PLAN UPDATES FOR CRUISING BOATS

CONTENTS

D268/11 Sail Plan - Al. Mast

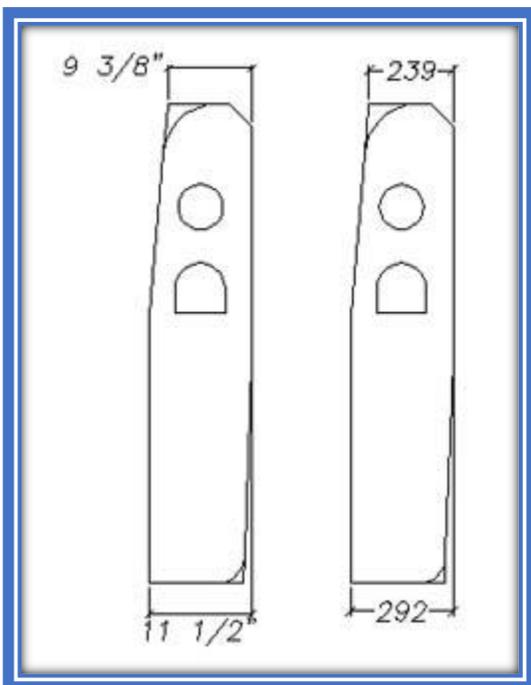
The distance from the top of the mast to the shroud attachment point is $63 \frac{7}{8}$ " [1622 mm]. The gooseneck height above the deck is 18" [457 mm].

VG18 UPDATE

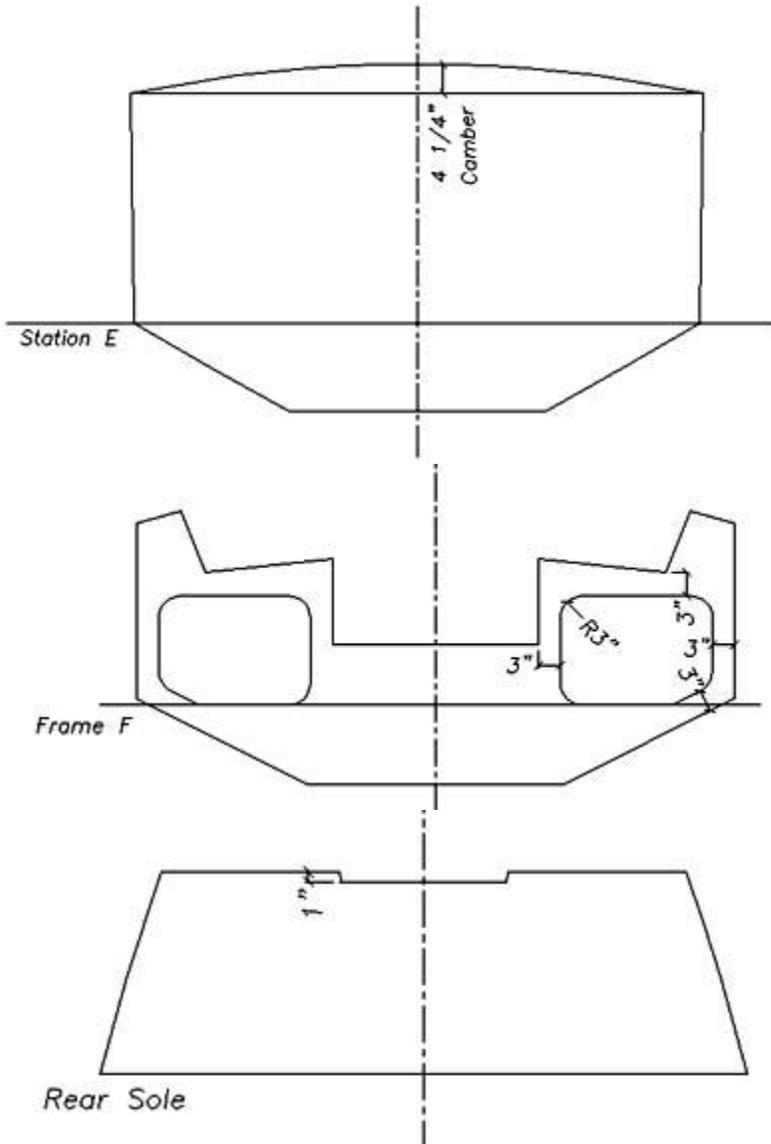
There were a couple of dimensions missing on the plans shipped before 08/22/05.

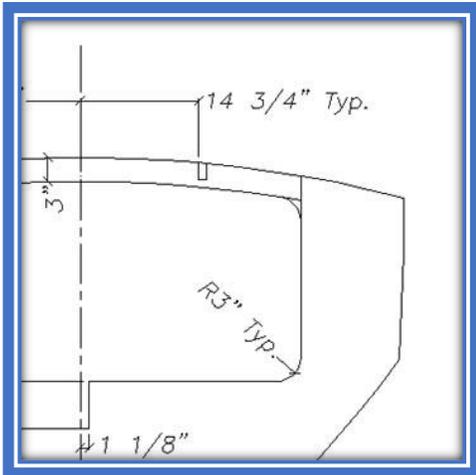
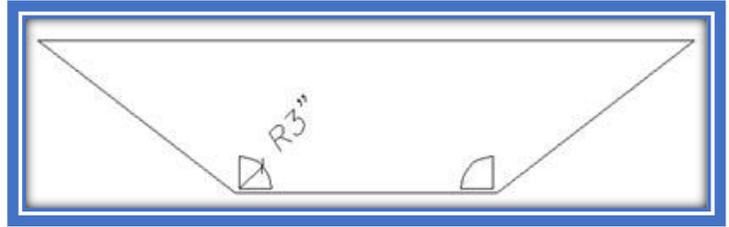
The plans did not show the cockpit drains and their dimensions: We suggest 3" [76] radius.

Also, the location and size of the longitudinal roof framing was not clear. They are 1" X 2" [25 X 51] on edge and 14 3/4" [375] from centerline.

OFFSHORE

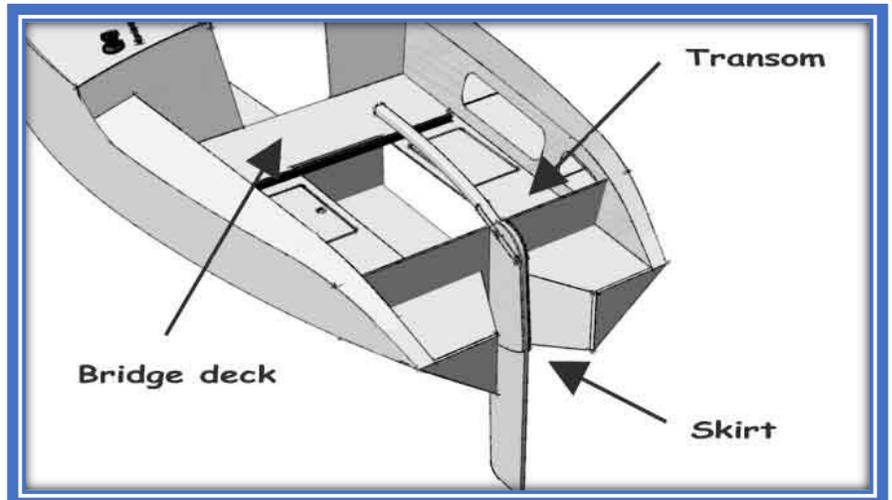
First, cockpit size is reduced. Forward, a bridge deck puts some distance between the cockpit and the companion way. On the stern side, the transom moves forward and the part behind it becomes a skirt. The smaller cockpit volume is an important safety factor in bad weather.

The rudder moves forward on the new transom and rotates in a slot just like in the VG20. The rudder gets better support and it will give better control in its new location. It can move up and down for shallow water sailing. The skeg became slightly larger for better tracking. The split backstay is connected to chainplates mounted on the new transom. The backstay moves to the new transom. This will limit the amount of roach in the main but that is perfect for long distance sailing.
